**CALIFORNIA INSTITUTE OF TECHNOLOGY**  
Laser Interferometer Gravitational Wave Observatory (LIGO) Project

To/Mail Code: Jordan Camp/102-33  
From/Mail Code: Alex Abramovici/102-33  
Phone/FAX: 395-4895/304-9834  
Refer to: LIGO P950028-00-R  
Date: April 30, 1995

**Subject:** Changes in fast PZT mirror design for the PSL

Fig. 1. Comparison between traditional (left) and modified (right) FPZTM designs

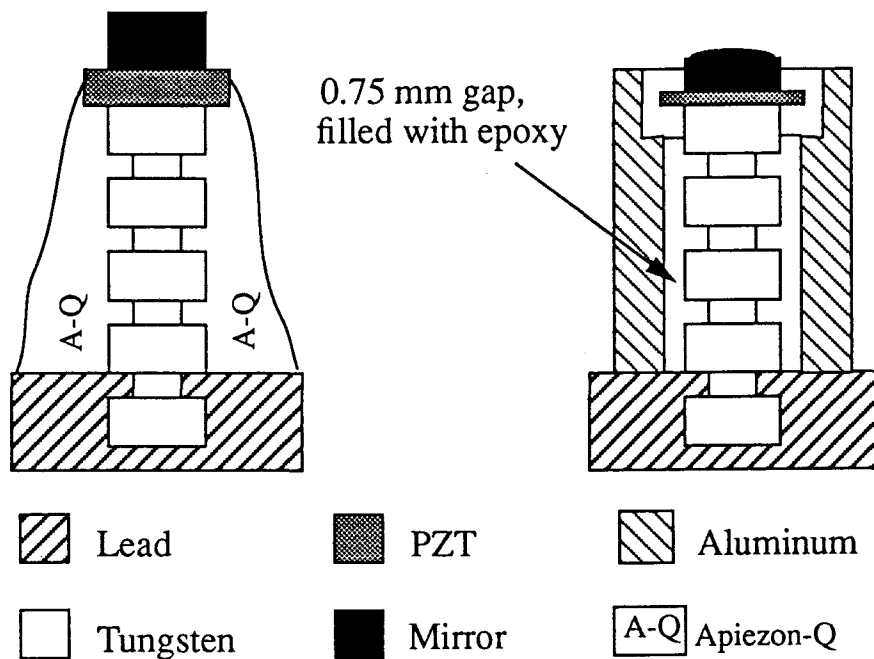
The changes in FPZTM design, and the resulting improvement in mirror performance, are summarized in Table 1 and in Figure 1. Constrained layer damping was adopted following a suggestion by Frederic Cleva (Orsay, France), who had successfully used it for FPZTM damping, and after the concept was clarified by consultation with Mike Gamble.

FPZTM characteristic	Traditional design	Modified design
Mirror figure	Flat	Convex, R=11 m
Mirror size	$\phi 7.75$ mm, 4 mm thick	$\phi 6$ mm, 2.5 mm thick
PZT disk size	$\phi 9.25$ mm, 1.25 mm thick	$\phi 9.25$ mm, 0.5 mm thick
Damping material	Apiezon-Q loaded with lead powder	Perkin-Elmer Vac-seal epoxy
Damping method	Embedding	Constrained layer
First resonance	220 kHz, Q=7	350 kHz, Q=4
PZT capacitance	1 nF	1.8 nF
